Subject: Safety Recall 04V-165

(Ford Number 04S13)

Certain 2001–2003 Model Year Escape Vehicles Equipped with 3.0L V6 Engine

Powertrain Control Module Re-Calibration

FIGURE 1

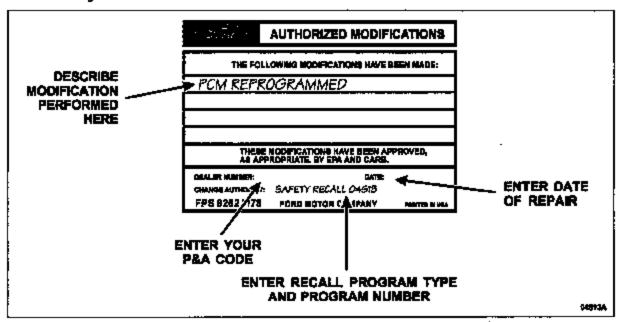
Obtain and prepare the Authorized Medifications Label. Describe the modification performed, and enter your PSA Code, date of repair and the recall program type and program number. See Figure 1.

- Clean an area on the upper radiator support.
- Apply the label to this clean area, then cover it with a clear plastic overlay.
